**WATER QUALITY
MEMORANDUM
Utah Coal Regulatory Program**

RE: 2009 4th Quarter Water Monitoring, UtahAmerican Energy Inc., Horse Canyon Complex, C/007/0013, WQ09-4, Task ID #3437

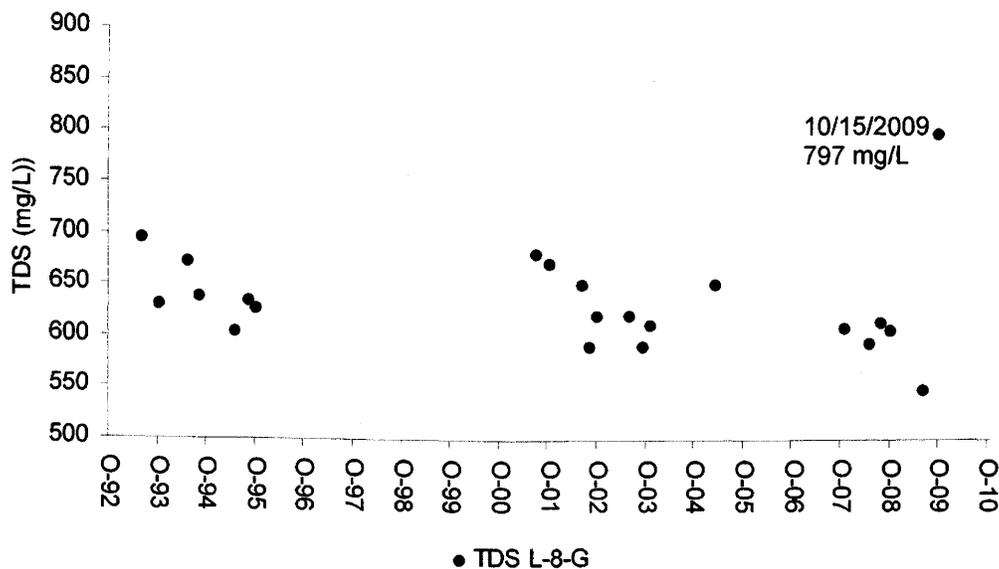
The reported pH values for springs L-7-G and L-9-G on October 15, 2009 were 6.3 and 6.29, respectively. These pH values are the lowest values reported to date at these sites and are less than the average values at these sites by greater than two times the respective standard deviations. The previous minimum pH values were 6.45 at site L-7-G on May 23, 1993 and 7.1 at site L-9-G on November 2, 2007.

The reported TDS for the sample collected at site L-8-G on October 15, 2009 was 797 mg/L. This TDS concentration is greater than the average concentration at this site by greater than two times the standard deviation, and is considerably greater than the previous maximum reported concentration at this site (694 mg/L for sample date June 4, 1993). The reported TDS concentration for the October 15, 2009 is much greater than the sum of dissolved constituent concentrations from the analysis (578 mg/L), and the ratio of conductivity to TDS (0.87) is outside the "rule of thumb" criteria of 0.55 to 0.75. The reported TDS concentration for 4th quarter 2009 was checked and confirmed by the Operator. The reason for the apparently elevated TDS result is not known; however, the TDS concentrations will be monitored and reviewed during subsequent sampling events.
